RE: JMC Project 20044
4 Tripp Lane Zoning Compliance
4 Tripp Lane
Town of North Castle, New York

Response to Kellard Sessions and Town of North Castle Planning Department Comments

This letter has been prepared to address comments in correspondence received from Kellard Sessions, dated November 22, 2022, and the Town's Planning Department staff report dated, October 13, 2022.

Drawn: DK Approved: AN
Scale: 1" = 20'
Date: 03/01/2021
Project No: 20044
20044-SITE DK GROSSLAND COV QLC-new15
Drawing No:
C-310

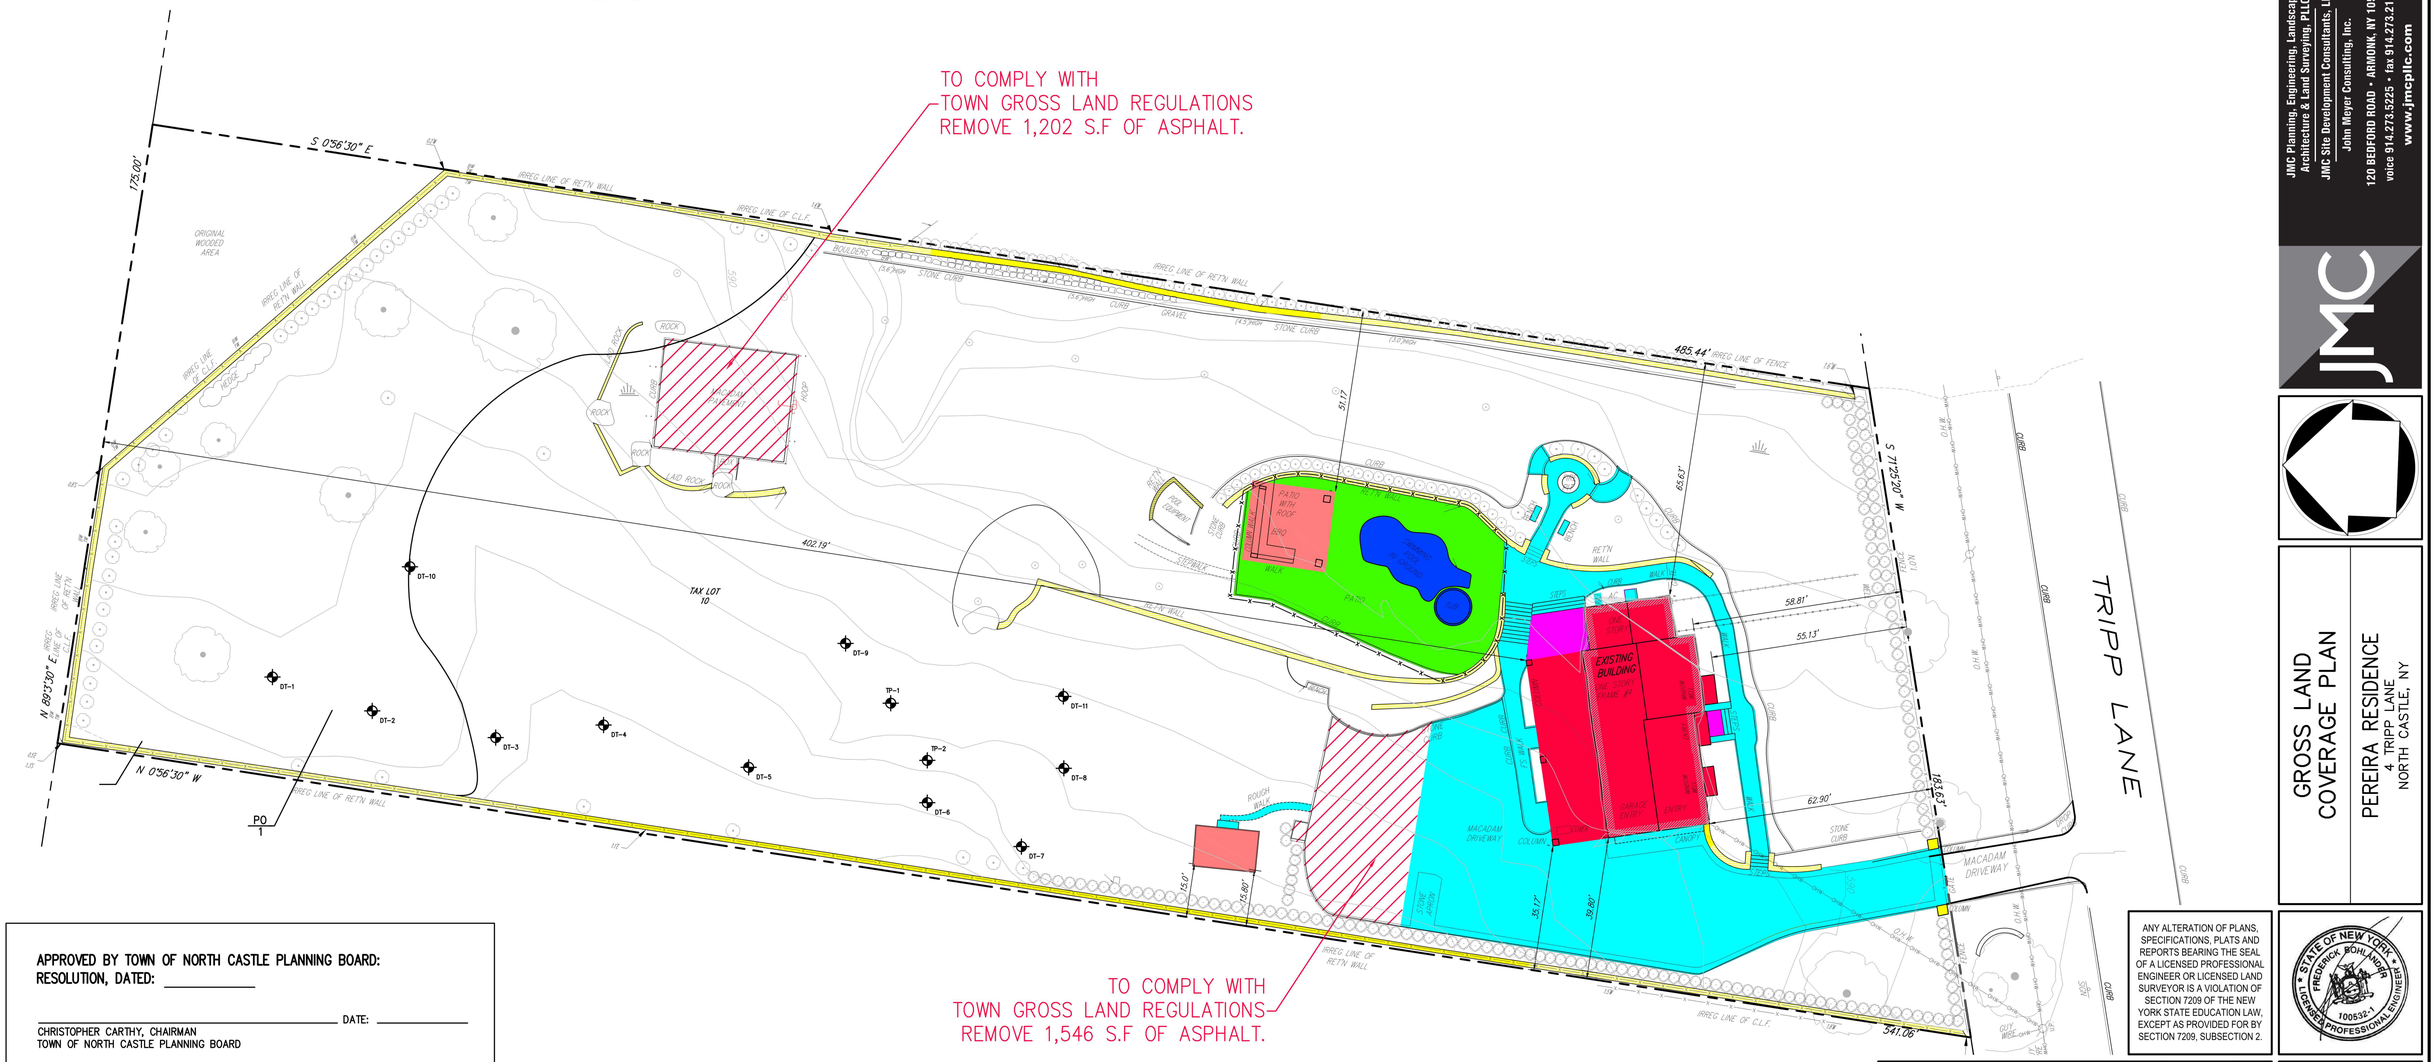
The applicant has provided a Gross Land Coverage Plan to demonstrate compliance with the maximum permitted gross land coverage for the zoning district. The plan indicates the removal of an existing sport court and a portion of the existing drive, both completed without permits, to reduce the land coverage, as necessary, to comply. We note, however, that the plan appears to require the addition of two areas of existing coverage, currently not accounted for; (1) the northernmost portion of the Boulder wall along the eastern property line appears to exceed 4 feet in height, and (2) the plan makes reference to a concrete patio north of the shed building. Although not shown on the plan, based on review of available Westchester County aerial mapping, the patio appears to exist. The plan shall be revised to include these additional coverage areas and the calculations adjusted accordingly so a determination can be made as to whether the total allowable coverage has been exceeded.

TO COMPLY WITH
TOWN GROSS LAND REGULATIONS
REMOVE 1,202 S.F OF ASPHALT.

TO COMPLY WITH
TOWN GROSS LAND REGULATIONS
REMOVE 1,546 S.F OF ASPHALT.

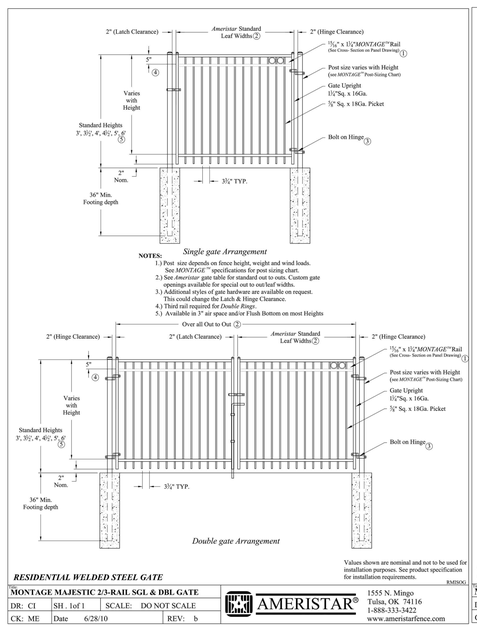
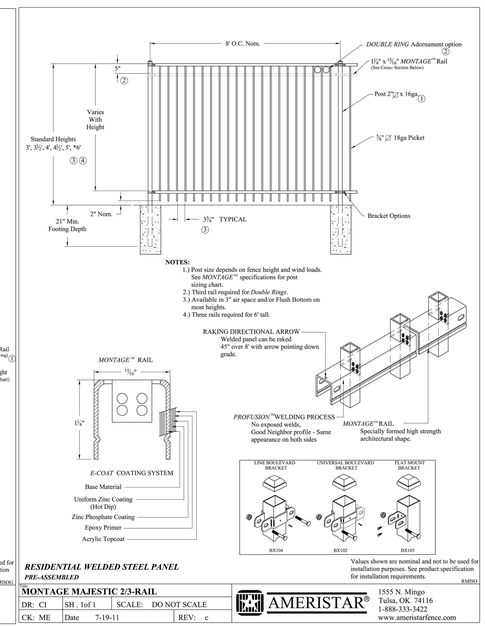
The plans call for a six (6) foot high black vinyl coated chain link fence; however, the two (2) fence details provided are for proposed fence of 5 feet 3 inches and 5 feet 2 inches. Please coordinate between the plan and details.

Additionally, the plan shall indicate a pool enclosure that complies with NYS Building Code.

The fence labels shown on JMC Drawing C-110 have been coordinated with details #10 and #11 shown on JMC Drawing C-901. A fence surrounding the pool area (including a gate) is now shown on the Site Plans and a detail of the fence and gate has been included on JMC Drawing C-900 as Detail #5.
